RE: Samson BD-04, T12S-R33E-Section 2, Unit Letter H
1R0474

Investigation/Characterization Workplan

**RE: NOTICE OF DEFICIENCY
FAILURE TO SUBMIT REMEDIATION PLAN AND FORM C-141
SAMSON RESOURCES - STATE BD NO. 4 LEASE
SECTION 2, TOWNSHIP 12 SOUTH, RANGE 33 EAST
LEA COUNTY, NEW MEXICO
1R0474**

Figure 1: Two-Screen Well

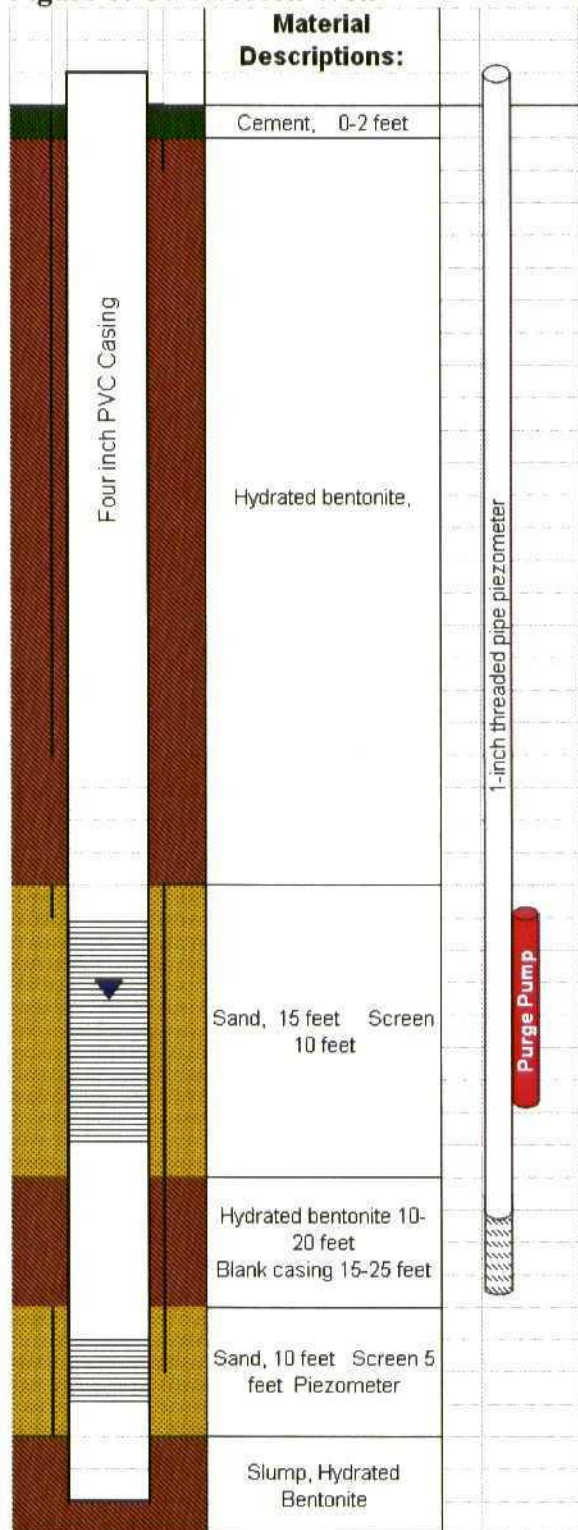
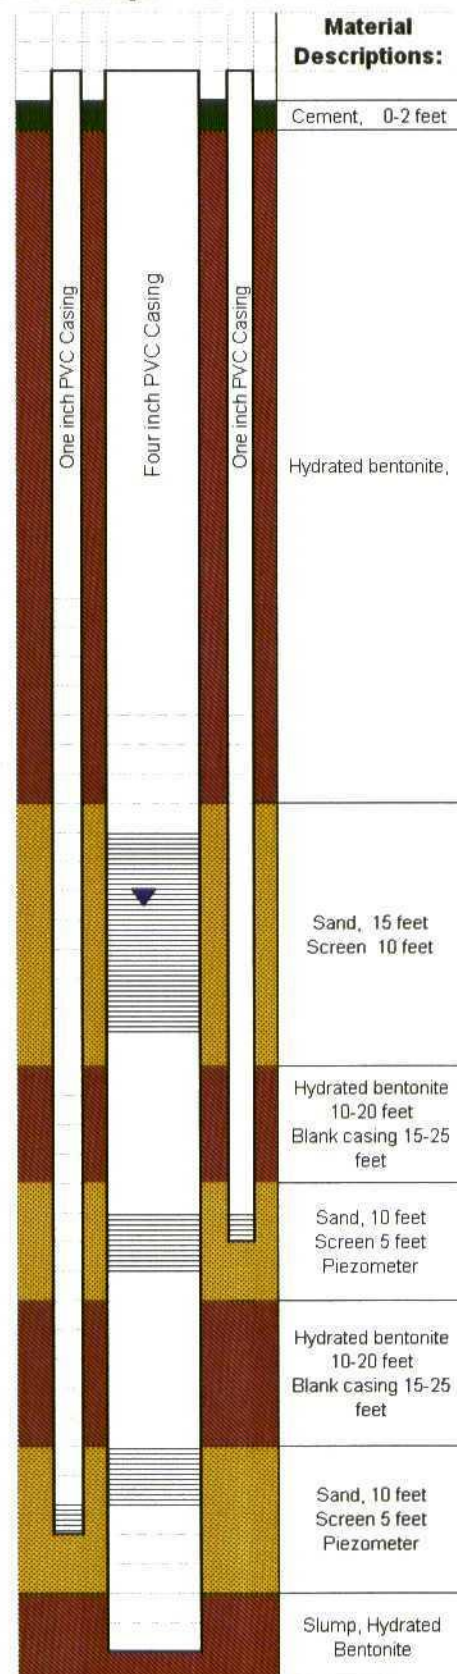
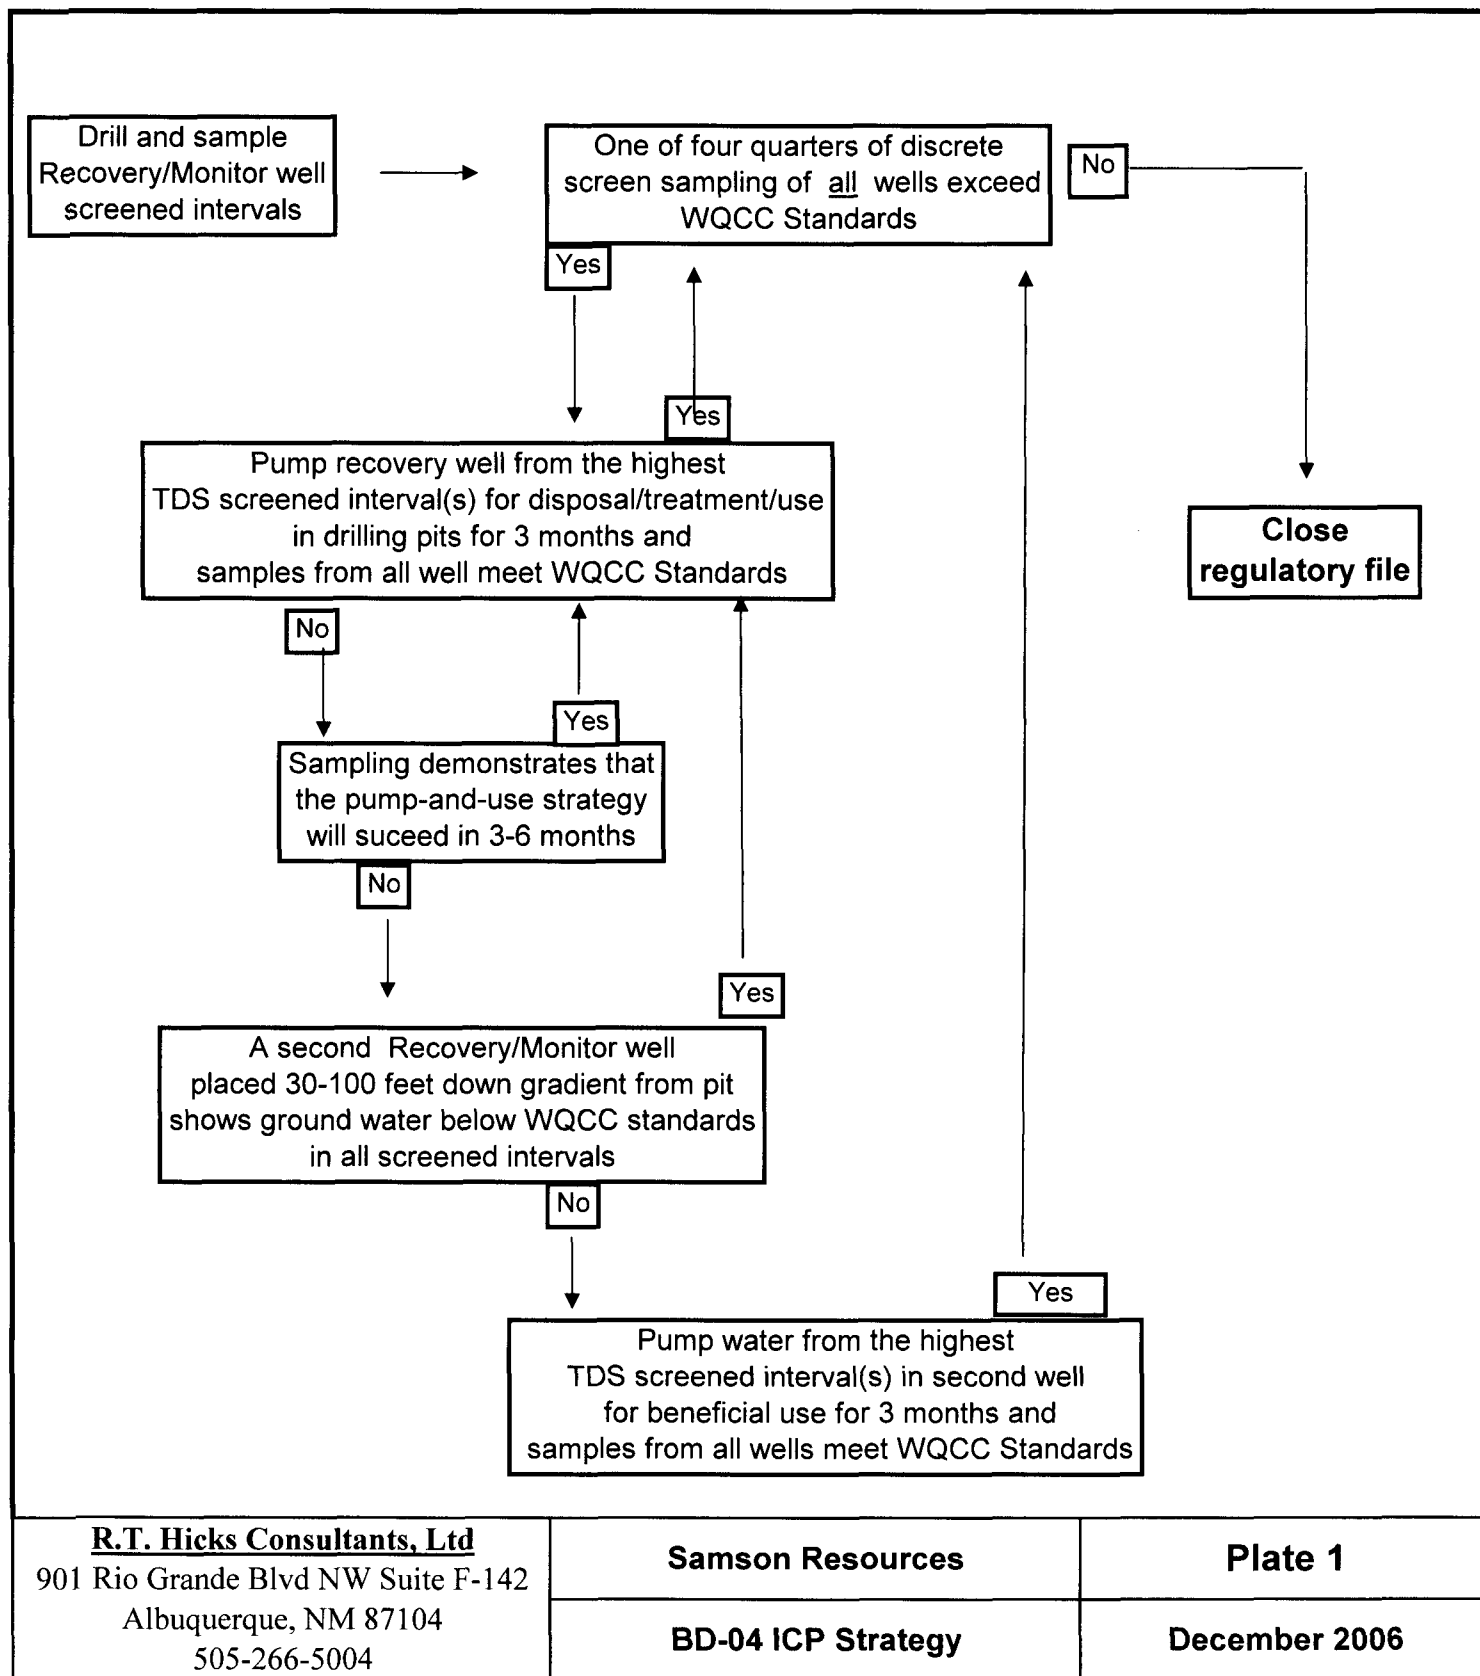
1. In a monitoring/recovery well with two screens (Figure 1):
 - a. Place a sampling pump between the uppermost screened interval and the second screen and purge the well at 0.5-2 GPM. This will cause water to flow into the well from the screened intervals above and below the pump.

- b. Lower a bailer into the well and capture a sample from the lower portion of the upper screened interval. This will provide a discrete sample from the uppermost portion of the saturated zone.

- c. Lower a bailer through a piezometer to capture a sample from below the pump. This sample will be a discrete sample from the horizon penetrated by the lower screen. Fixing the purge pump to the piezometers can minimize the tangle of hoses that creates difficulties with lowering a bailer to capture a sample from the upper screen.
